**SUBMITTAL OF REMEDIAL INVESTIGATION  
FEASIBILITY STUDY (RI/FS) WORK PLAN  
ADDENDUM (31 ADDITIONAL MONITORING  
WELLS PROGRAM) TO U.S. EPA/OEPA**

**DOE-958-90  
DOE-FMPC/EPA  
26  
ADDENDUM**

# DOCUMENT CHANGE REQUEST

REQUEST NO. 38

**FIGURE 1**  
EXISTING AND PROPOSED WELL LOCATIONS

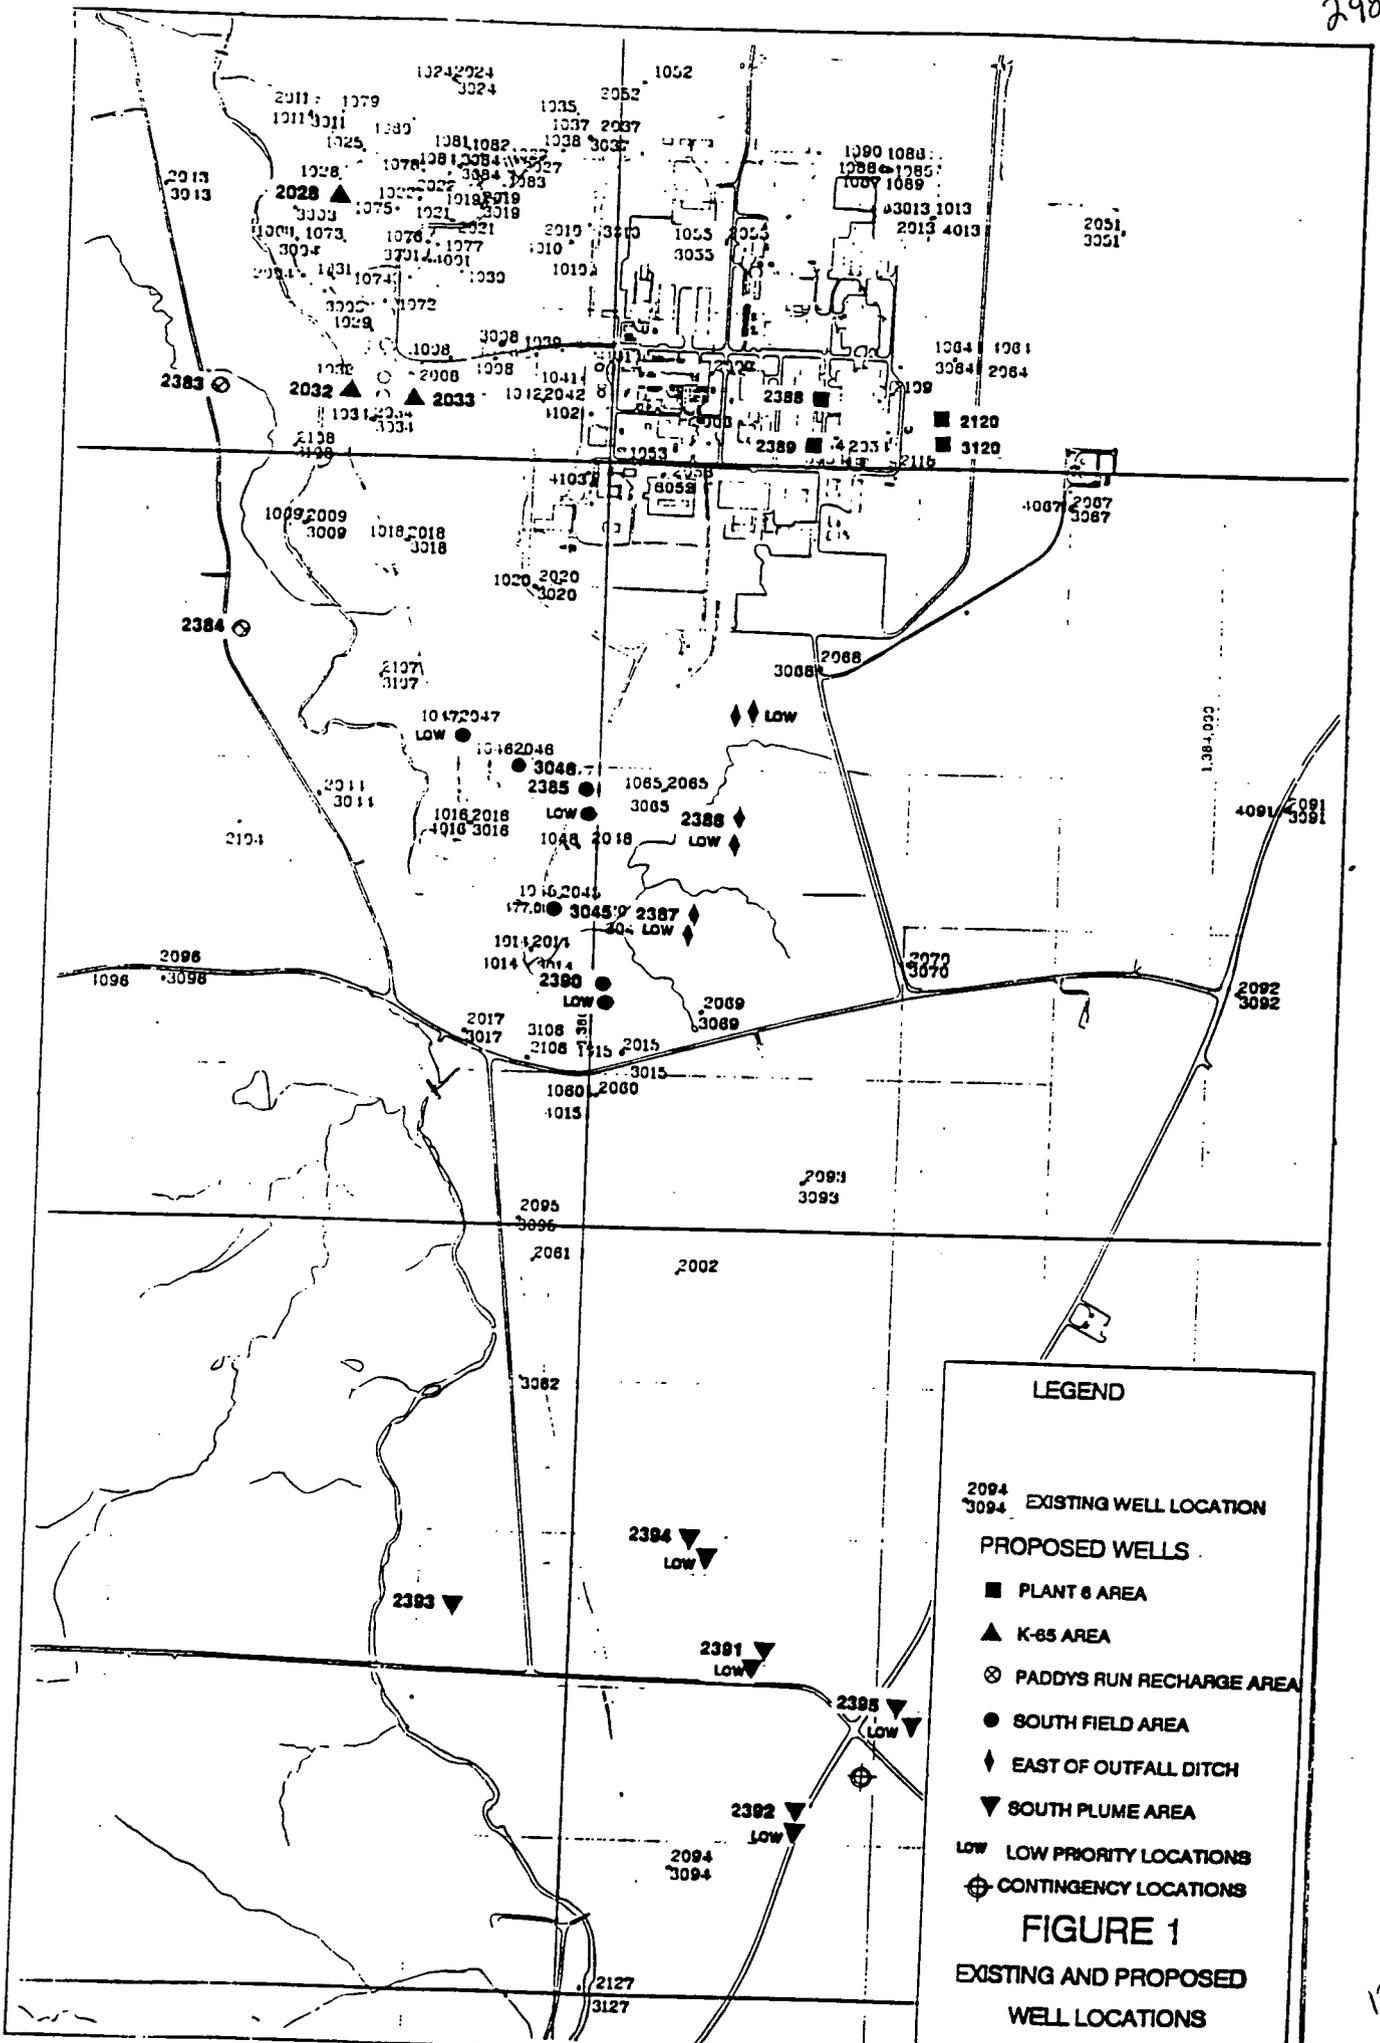
Justification for individual wells is presented in terms of the needs of individual operable units. The locations of all the wells are shown in Figure 1. Table 1 indicates if the wells are a high or low priority.

Two 2000-series wells are proposed for the western boundary of the FMPC as shown in Figure 1. Wells 2383 and 2384 will provide the water level and water chemistry data required to determine the significance and extent of the temporary ground water gradient reversal.

In the event that well 2391 contains elevated levels of uranium in excess of 50 ug/l then well 2392 should be installed at the location shown in Figure 1, to determine the lateral extent of the plume and well 3391 installed to determine the vertical extent of the plume. If uranium is less than 50 ug/l then the next 2000 series well should be installed northwest of well 2391. In either case the result will be wells at adjacent locations that define or closely locate the southern extent of the plume and provide the necessary data to complete the calibration of the transport model.

Initial water level data from the PRRS RI/FS piezometers indicate that well 2393 should be installed on Rutgers Nease property as shown in Figure 1. This well will fill a large data gap between the other PRRS wells and the Fernald RI/FS wells and should

FIGURE 5

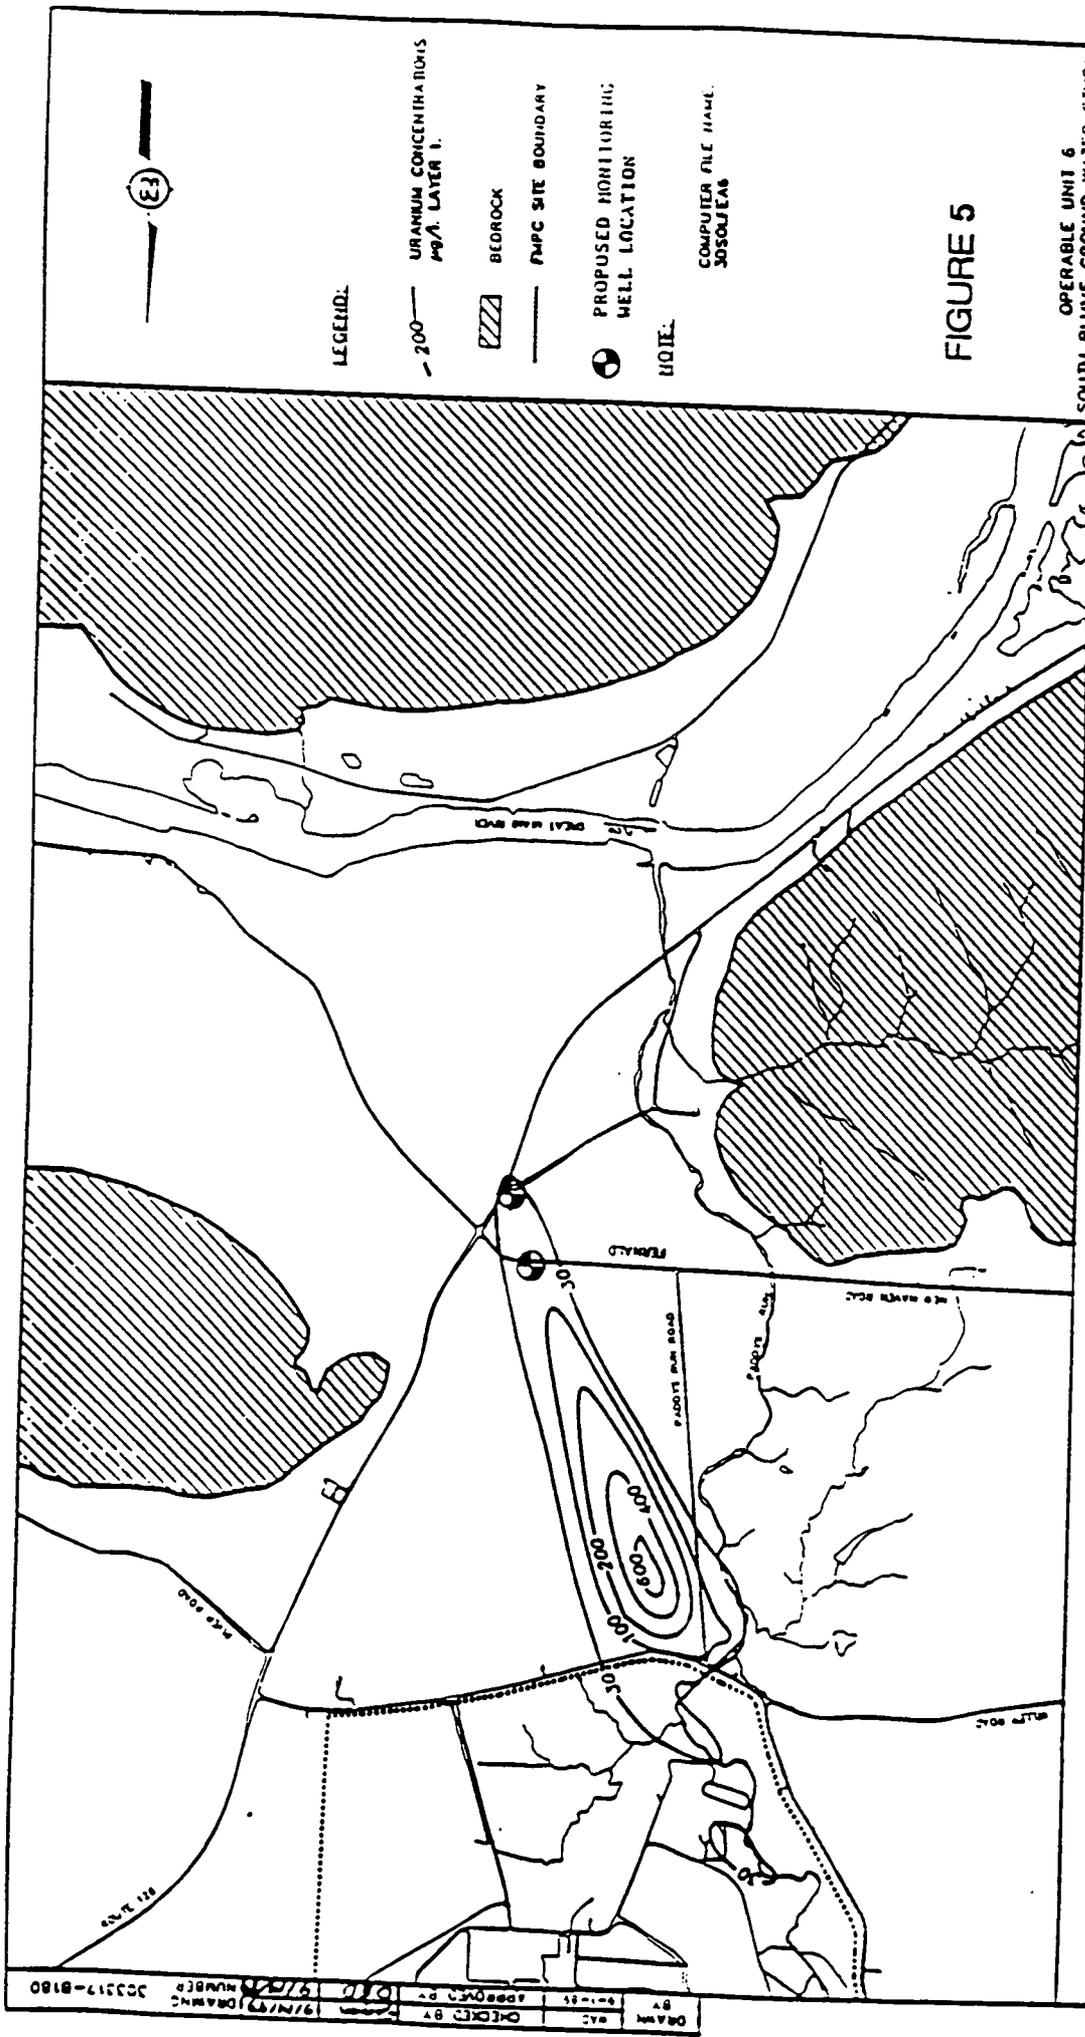
Current model interpretations indicate that the main plume has a long slender shape and that it extends a considerable distance to the southeast as shown in Figure 5. The location of the southern third of the plume is farther to the east than any drilling program proposed by either RI/FS. Well 2391 should be installed at the location shown in Figure 1, to determine if the model prediction of the southern tip of the plume is accurate. The appearance of 4.5 ug/l uranium in well 2094 in January 1988, while not a high value, indicates that uranium is present in the area. Location 094 is downgradient from the location of the two proposed wells in the PRRS RI/FS.
